## ADDENDUM # 1

**Sewer Lift Station Replacements  
Bid No. #2016-09**

City of Carlsbad

This addendum forms a part of the Contract Documents and modifies the original specifications and drawings dated March 11, 2016. Acknowledge receipt of this addendum in the space provided in the Bid Form. Failure to do so may subject the bidder to disqualification.

BHI PROJECT NO.	20150413	DWG NO.	LS1-C3	SHEET	12	OF	54
-----------------	----------	---------	--------	-------	----	----	----

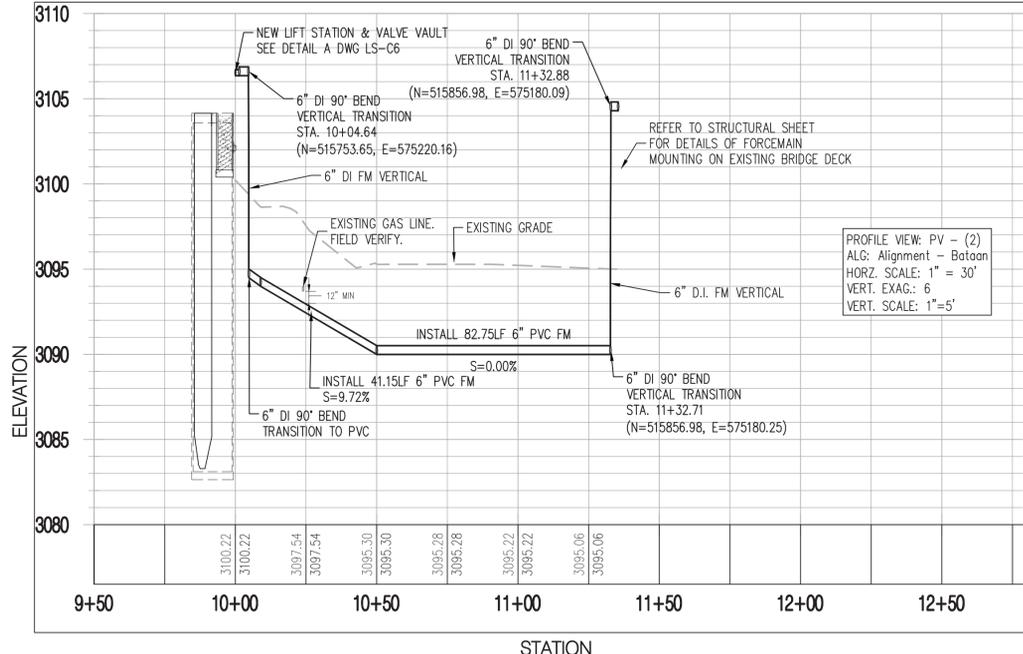
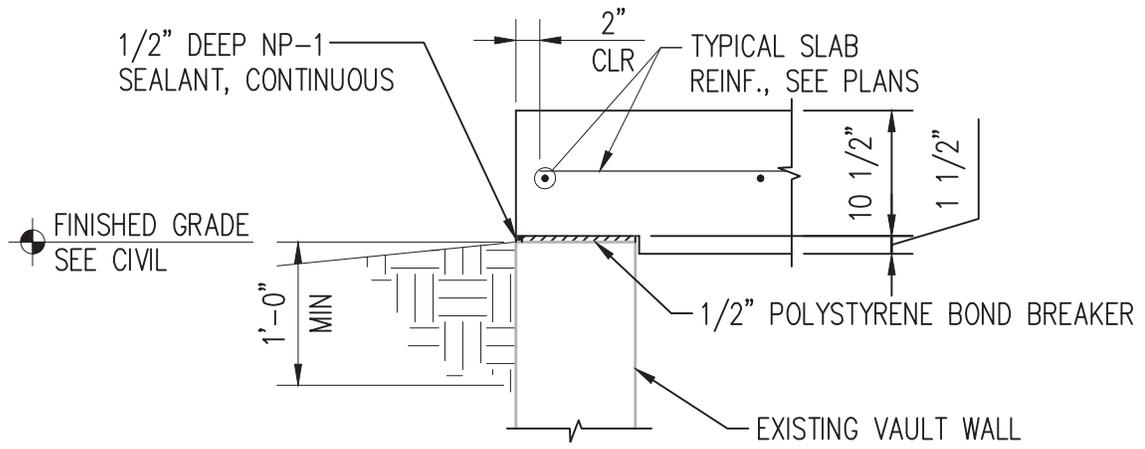
11. **Question:** Plan Sheet LS1-C3, Profile appears to indicate that the 6" DI Force main will discharge from the Valve vault above Grade, is that correct?

16. **Question:** Plan sheet LS1-C3 and D-S2: C3 calls out the SAS FM as C900 PVC, while section A on D-S2 shows that same section as 6" Ductile Iron. Please clarify what type of pipe will be required?

**Answer:** Yes, that is correct.

**Answer:** Section A on drawing D-S2 shall say C-900 PVC for underground pipeline and ductile iron for aboveground pipeline.
